RESPONSE TO REQUEST FOR ADDITIONAL INFORMATION

**SAFETY SYSTEM DIGITAL PLATFORM
- MELTAC (MITSUBISHI ELECTRIC TOTAL ADVANCED CONTROLLER) -
TOPICAL REPORT**

TAC NO.: MF4228
RAI NO.: #1
DATE OF RAI ISSUE: 6/29/2016

QUESTION NO.: 9 for JEXU-1041-1008, "Safety System Digital Platform – MELTAC"

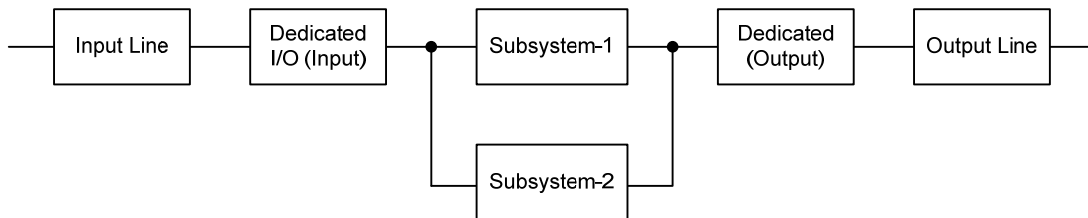
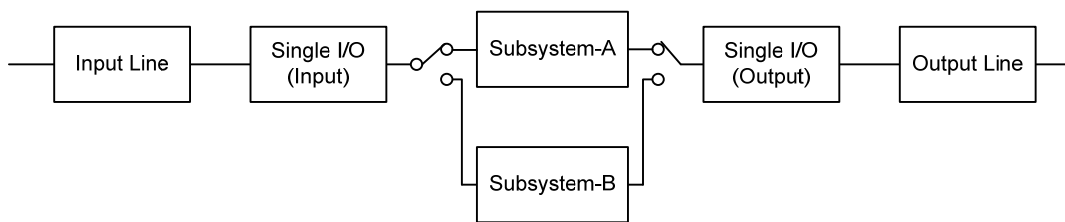
Page 214 of the TR discusses the generic redundant parallel controller reliability analysis and a fault tree analysis to support that controller configuration review. The NRC staff needs to review this specific analysis and additional analyses for other controller configurations and modules that are included in the MELCO platform to complete its evaluation in accordance with ISG-06 Section D.9.4.2.1.1. Please provide a description of the criteria used to determine which controller configuration will be used (i.e. single, redundant parallel or redundant standby) as well as documentation to demonstrate compliance of other possible controller configurations to this criteria.

Section 7.2, "Controller Reliability Analysis" pertains to frequency of failures for the three controller configurations that can be applied with MELTAC. These are single, redundant parallel, and redundant standby (described in Section 4.1.1). Among these configurations, the configuration that can satisfy the plant specific reliability requirements is applied, with consideration of both actuation assurance and spurious actuation prevention. The actual reliability calculations are in plant specific documentation. The reliability models shown in Section 7.2 are intended to only show the reliability analysis method for each of the three basic controller configurations. The reliability models of these configurations are shown in Figure 1, Figure 2 and Figure 3, respectively.

Each configuration has one input module and one output module as a single I/O module. Redundant I/O modules can also be applied, as described in Section 4.1.1; for simplicity, these reliability models show only single I/O modules.

A comparison of the three controller subsystem configurations is described below. This comparison excludes the reliability of the single I/O modules, which is common to each configuration.
